RE: February 3rd Note to File

In correspondence posted to the public registry on February 3rd, 2010, Dezé Energy Corporation (Dezé) was asked to respond to specific questions concerned with the potential re-routing of the transmission line.

Figure A - Marine Cable Terminal Structure Example

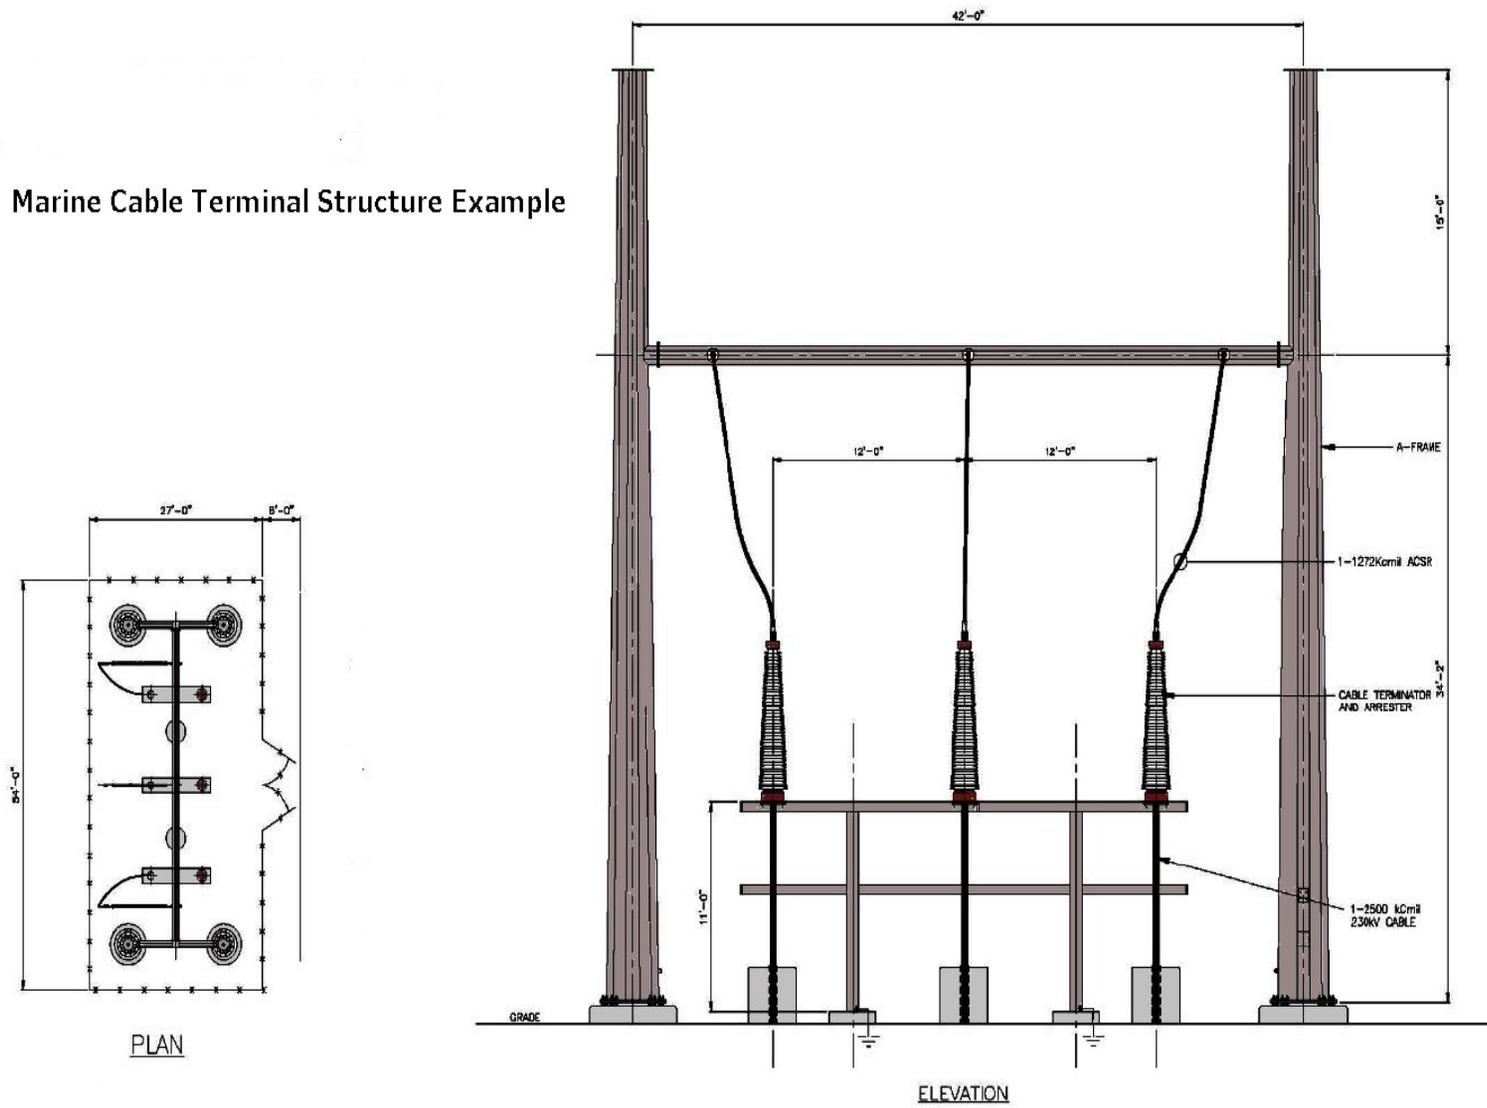
- A. Feasibility and rough overall cost of running the line underwater for the length of Maufelly Point and Fairchild Point.**
- B. The height and general features of the towers required on either side of the aerial crossing spanning the two points.**

- A marine cable span of approximately 20 kilometres would be required;
- There would need to be significant substation structures at each end of the marine cable sections - *Figure A - Marine Cable Terminal Structure Example*;
- Reliability concerns with marine cable options as outlined in the DAR remain and cannot be reasonably mitigated; and
- Additional capital costs to the preferred route in the range of \$25 Million would be required for this section of line and associated infrastructure.
